Application No. 10/616,238
Amendment Dated November 22, 2004
In Reply to Office Action dated July 23, 2004

Remarks

FIG. 1

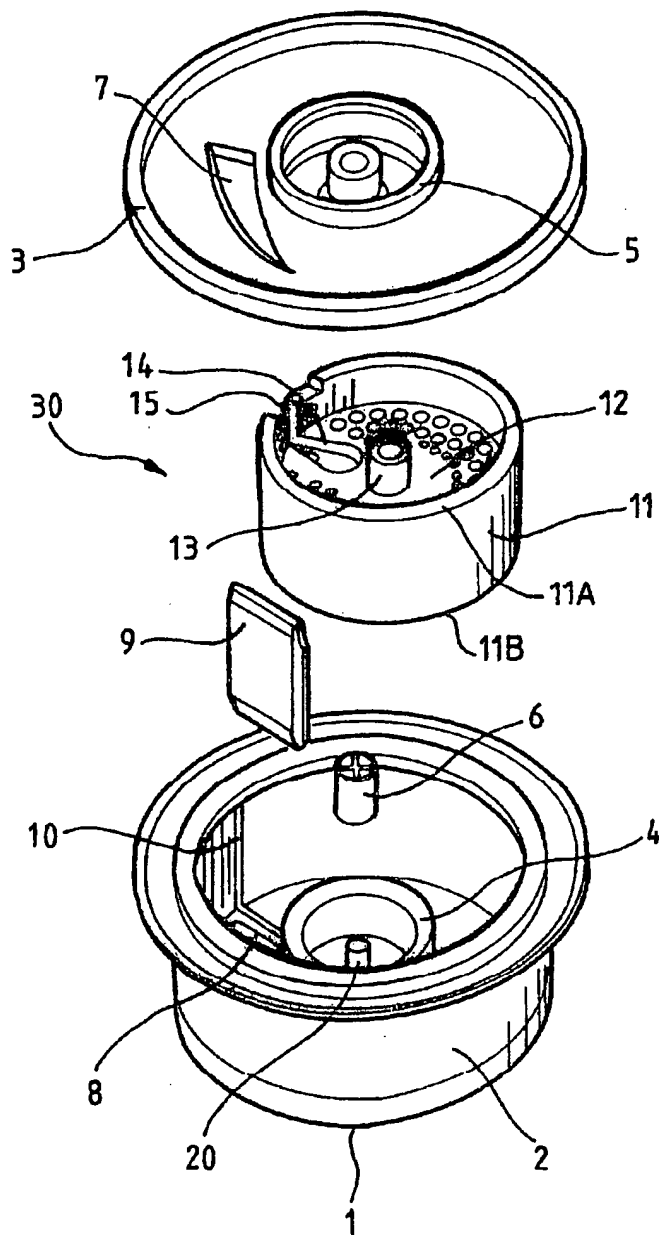
In paragraph 2 of the Office Action, the Examiner has objected to Figure 1 because it does not include the legend "Prior Art." Applicants have amended Figure 1 accordingly, and respectfully request that this objection be withdrawn.

The attached sheets of drawings include changes to Figures 1 and 2. Sheet 1, which includes Figure 1, replaces the original sheet 1 including Figure 1. Sheet 2, which includes Figure 2, replaces the original sheet 2 including Figure 2. In Figure 1, the legend "Prior Art" has been added. In Figure 2, the element number "16" has been added.
